Review of Molikpaq Geotechnical Material

March 2009

Review of Molikpaq Geotechnical Material

Second Report
(Draft)

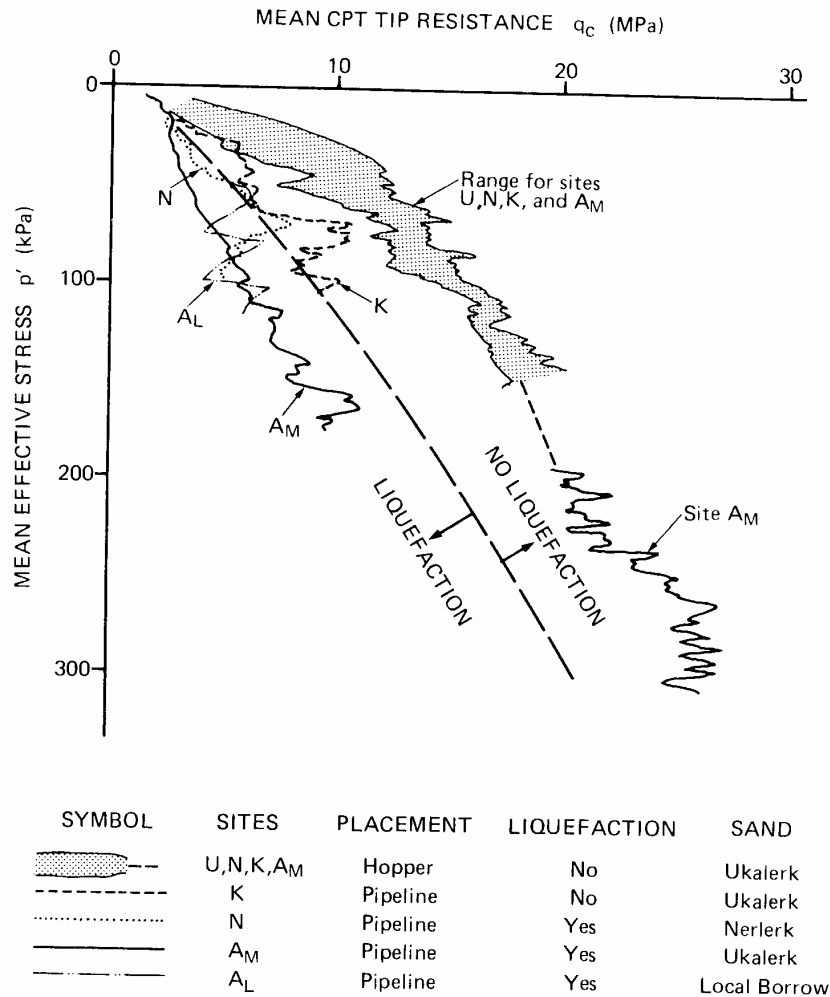
There are ample evidences in the literature that for a given sand there is a reasonably unique relationship between void ratio, e, mean effective stress, p', and CPT tip resistance, q_c (Schmertmann 1977, Villet and Mitchell 1981, Baldi et al. 1986, among others). The void ratio, e, can be expressed in different forms. Hewitt (2008) expresss it in terms of relative density, D_r, following the work of Baldi et al. (1986) as shown in Figure 2. This figure shows the relationship between p', D_r, and q_c as determined from pressure chamber tests in the laboratory. Based on this relationship, and from the cone penetration resistance, q_c, measured in the field, Sladen and Hewitt (1989) are able to determine the D_r (or void ratio) of 4 hydraulic fills in the Canadian Beaufort Sea. As postulated in this approach that D_r and q_c are uniquely related for a given sand at a given p', the measured q_c profile measured in the field can be replaced by D_r as shown in Figure 3. Based on observations of cases of similar soils that have failed in liquefaction and cases that have not, Sladen and Hewitt (1989) draw a line of demarcation separating dilative (potentially non liquefiable) from contractive (potentially liquefiable) soils

(Figure 4). This line of demarcation, however, has not been used in Hewitt's report (2008). His conclusion of a loose (contractive) core sand in this case, however, is based on the following:

Figure 5 CPT Tip Resistance Profile for the Amuligak I-65 Core Sand

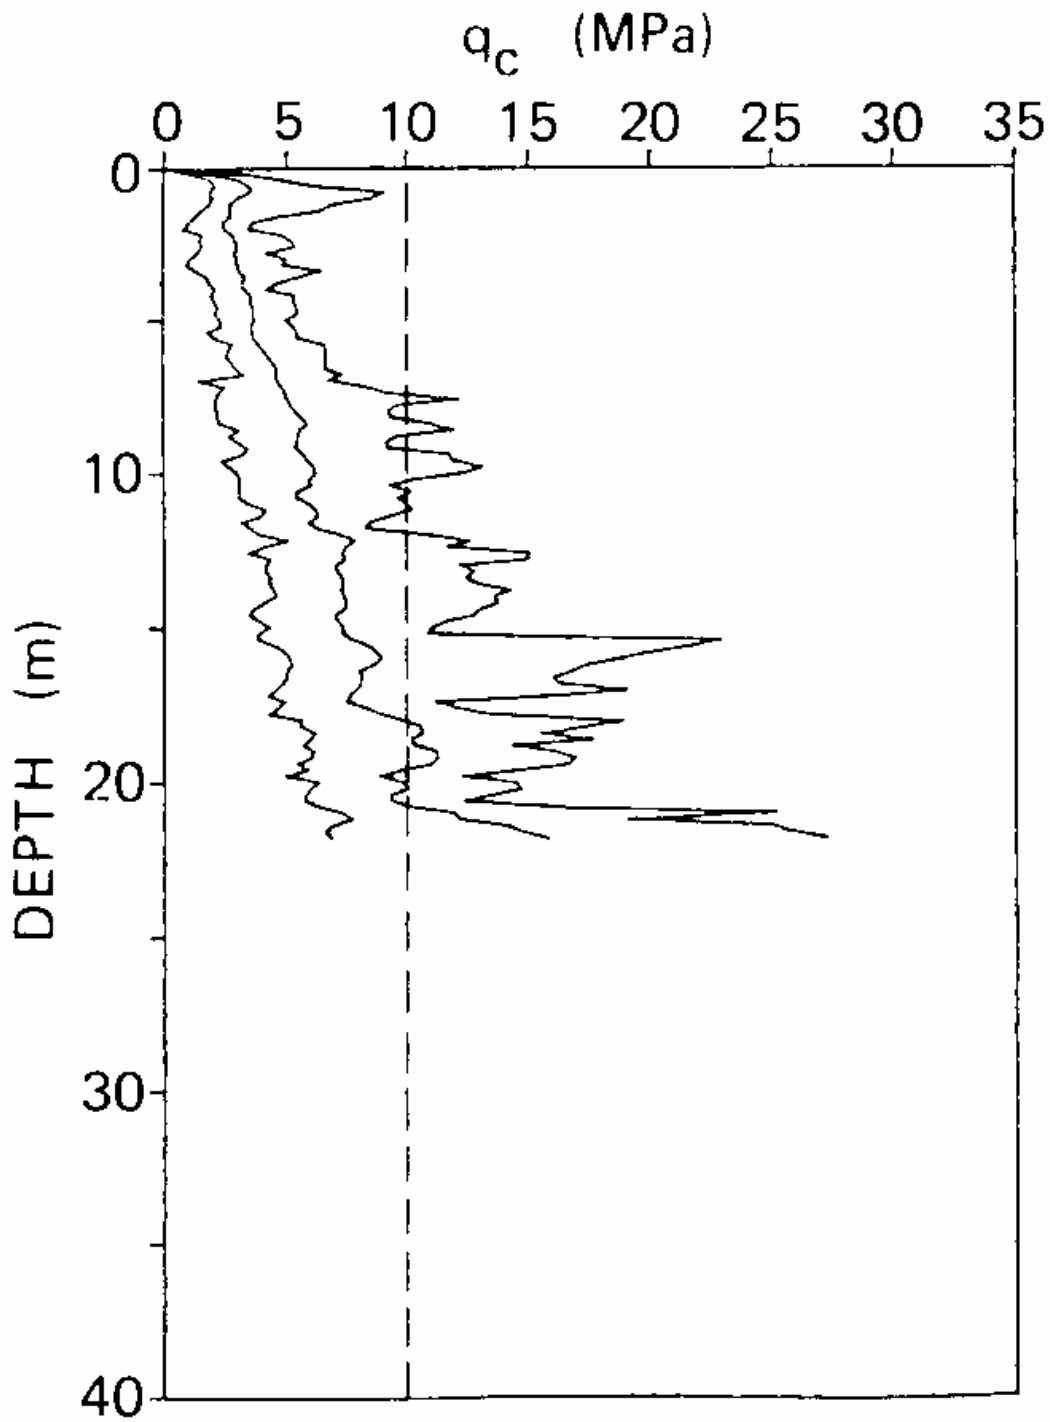
Based on the CPT results given by Sladen and Hewitt (1989), the pipeline placed core sand at Amauligak I-65 is quite variable. At a given depth, the maximum tip resistance is two to five times the minimum value (Figure 5). This is not surprising for a hydraulic fill placed with pipeline discharge under water. With such a large variability, it is likely that the core sand as placed would have strong and weak zones. Even under uniform load intensity, these strong and weak zones will respond differently. During the 1986 April 12 event, the loading intensity varies significantly with location. The east caisson face experienced large accelerations up to 8%g while the other faces experienced only 1-2%g. Soil variability and varying load intensity caused some parts of the core sand to liquefy and other parts to remain intact. This is consistent with the observed variation of surface settlement after the event (Figure 6). The settlement plates at about 0.5m below the sand surface showed a maximum settlement of 1.31m on one side (east side) of the fill but hardly any settlement at the centre, the west and the north sides.

Figure 3: Predicted Horizontal Displacement at Point of Load Application
(Hewitt 2009)

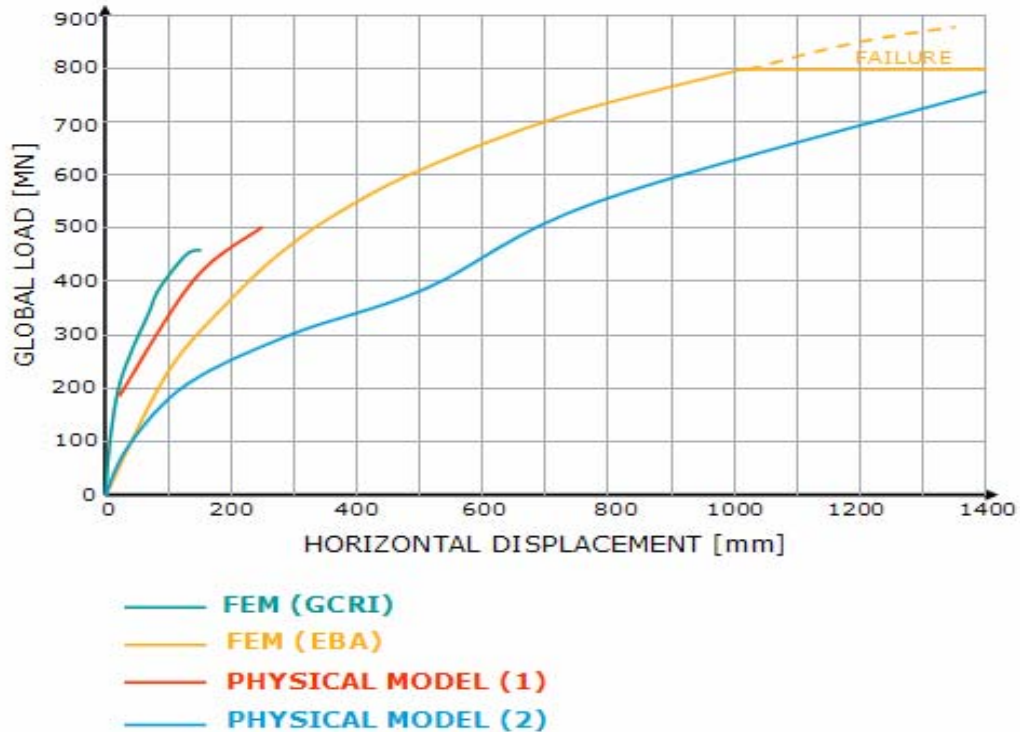
Hewitt's argument is based mainly on considering the loose nature of the core sand and the small measured horizontal movements of the Molikpaq. These two quantities together can only lead to an ice load significantly lower than that deduced from Medof panels or strain gauges. He summarizes the results of numerical modelling (FEM GCRI and FEM EBA) and physical modelling (centrifuge tests) in Figure 3. This figure shows that a loose core sand will displace a lot more than a medium dense or dense core sand. Based on a horizontal displacement after the ice event of about 30mm and a geotechnical model of a loose core sand, elastic strain being larger than the residual strain reflected

after the ice event, and frictional resistance between the berm and the caisson base, Hewitt obtains an estimated ice load of 220MN. He also supports his estimate of low ice load with three case records in Beaufort Sea.

Figure 4 Summary of caisson load-displacement behaviour – Categories A/B, C, D

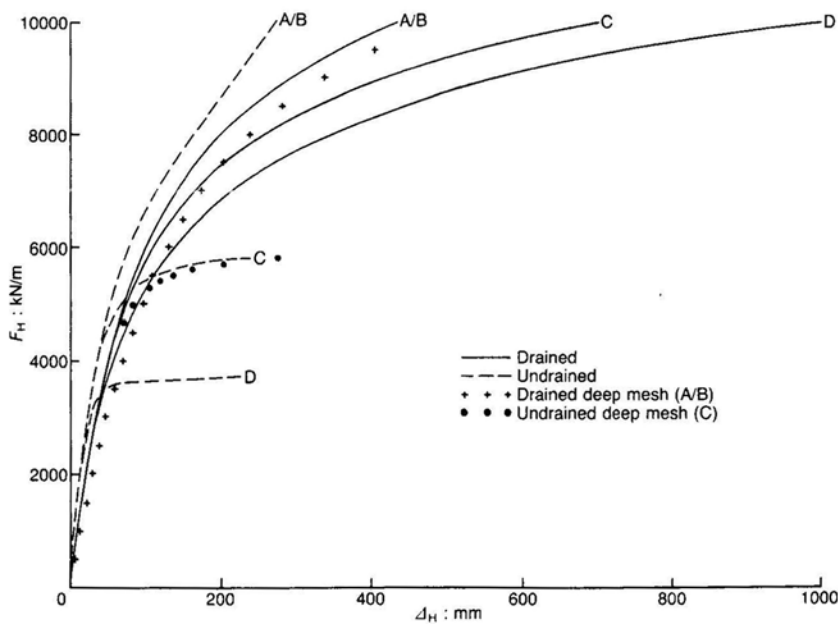
The results of Hicks and Smith (1988) in Figure 4 are new in the KCB report and not in their original work. Presumably the soil models chosen correspond to $\psi = -0.025$ and -0.075 for the core sand and the berm material, respectively. These values are closely similar to those chosen in the KCB report in their new numerical analysis to evaluate the ice load-"ovalling" relationship.

Figure 4 shows the horizontal movements at the point of load application for different soil states and different drainage conditions. The three soil states A/B, C and D correspond to mildly dilative core and stronger dilative berm, looses core and berm and very loose core and berm, respectively. At applied loads producing small horizontal displacements at the measured value of about 20mm, the load-displacement relationship remains unchanged for the three cases. That means at such low horizontal displacement, the ice load is independent of the state of the core sand. At this displacement, the ice loads are estimated at 2.7 and 1.8 MN/m for the undrainded and the drained cases, respectively. Based on the KCB method of calculation (74m wide normally loaded face and a factor of 1.25 to give the global load), these ice loads per unit width correspond to global ice loads of 247MN and 167MN, respectively. On the other hand, at a horizontal movement of 20mm at the core surface at inclinometer I2, the corresponding ice load is estimated at 5.0MN/m for the A/B case under drained loading followed by drained unloading (463MN using the KCB calculation). This significant difference in the estimated ice load for the same magnitude of horizontal movement at two different locations has not been mentioned or explained by Hicks and Smith (1988).

Interestingly, the first set of values of 247 and 167 MN agrees more with Hewitt's estimate of ice load while the second value agrees more with the KCB estimate. In the KCB report, the estimated ice loads at the inclinometer location have been discussed in details taking the out of plane displacement and other factors into account. The reported ice load based on "ovalling" (not horizontal movement of the core sand) is estimated at 425MN. This estimated ice load based on "ovalling" is not in the original work of Hicks and Smith (1988) and yet the KCB report still considers the work is of Class A prediction category.
